**47 Johnston Road, Mossman Gorge, MCU (Retirement Facility)  
Information request response (pursuant to Section 13 of the Development Assessment Rules)  
Your Ref: MCUC 2023\_5532/1**

### **Information Request Response - 47 Johnston Road, Mossman .**

MOSSMAN RETIREMENT VILLAGE  
 CATCHMENT PLAN - PROPOSED CASE

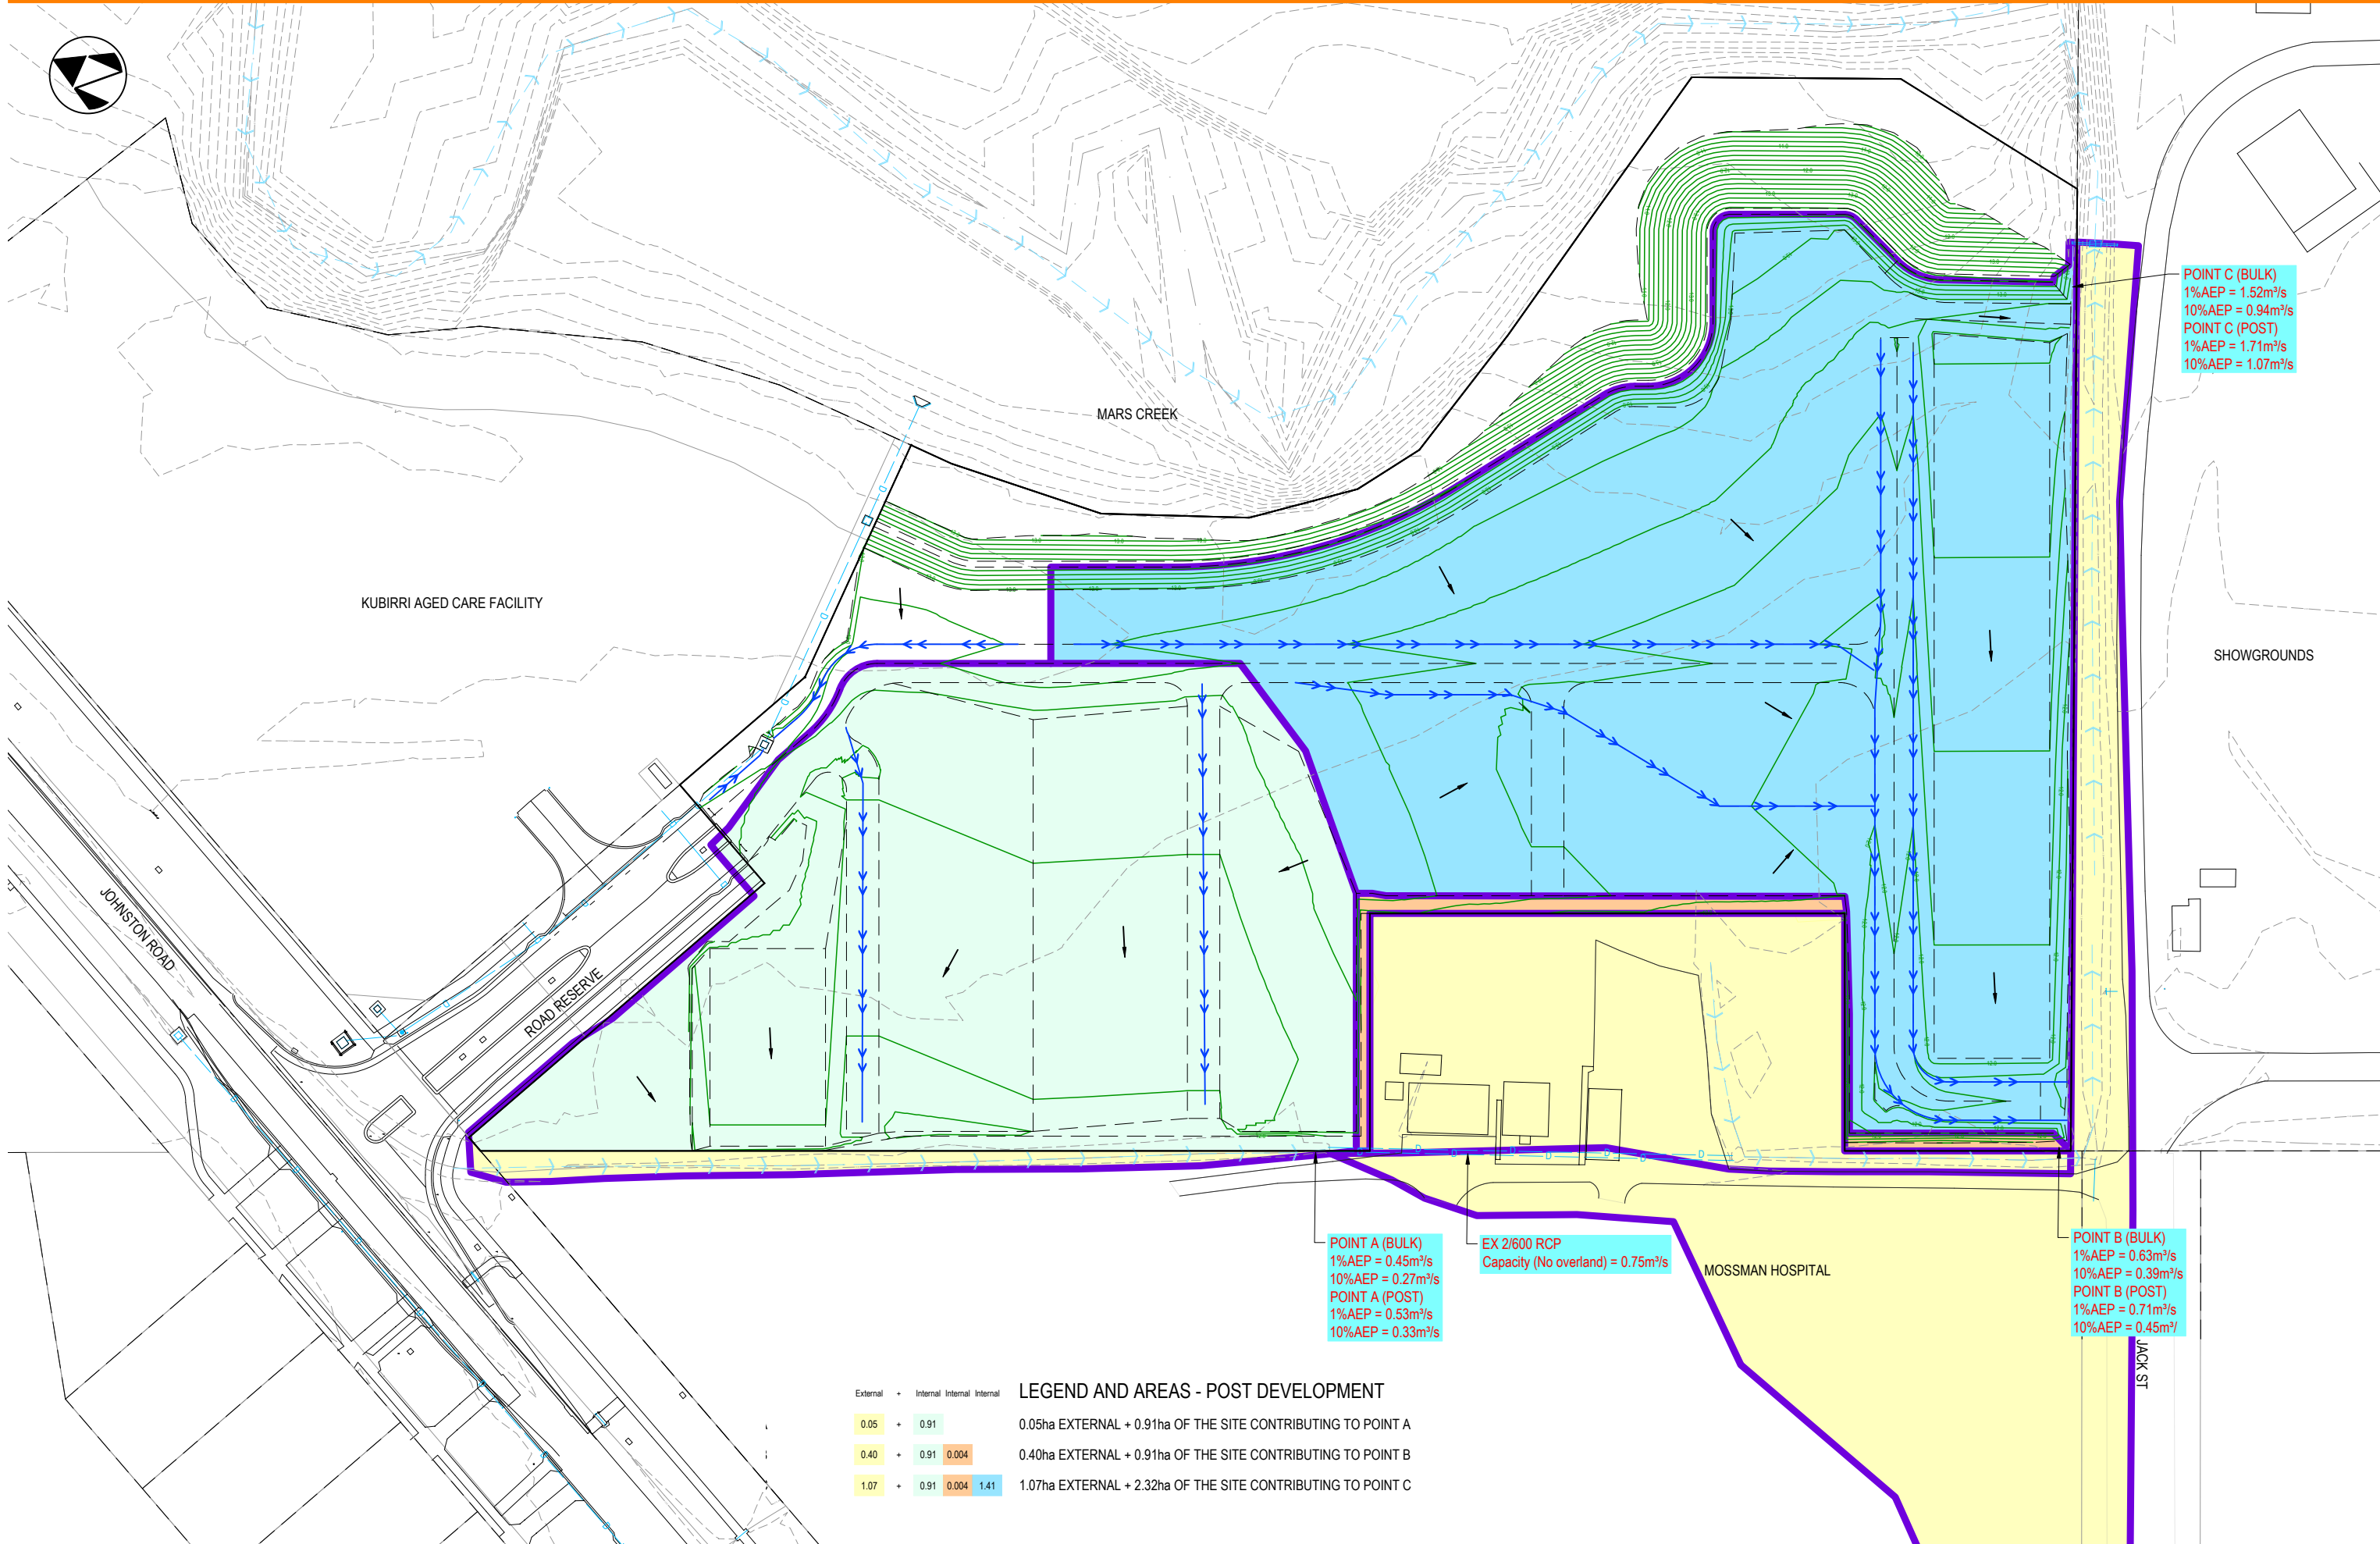
9. *The Applicant is requested to provide updated local drainage catchment plan(s) and calculations of the site, noting the apparent catchment changes discharging North to the Showgrounds drains. The additional information must consider the drainage impacts on downstream properties and the potential capacity upgrades to address the changed flows. In particular, the plan(s) and drainage advice must address the following:*

*e. Provide advice on how the layout achieves lawful points of discharge. Officers note that stormwater runoff is proposed to be discharged to neighbouring lots, that is the open drain along the eastern site boundary (within Lot 149 on SR587) and open drain along the northern site boundary (within Lot 92 on SR81);*

Additional catchment plans have been attached.

The layout satisfies criteria (i) of the lawful point of discharge in the Queensland Urban Drainage Manual 2017 (section 3.9) in that the site discharges to these locations in the current form and that the runoff from the development can be conveyed by the open drain and pipe work within these flow paths. The post development flow at Point A in a 1% AEP event will increase by 40L/s while Point B will decrease by 220L/s.
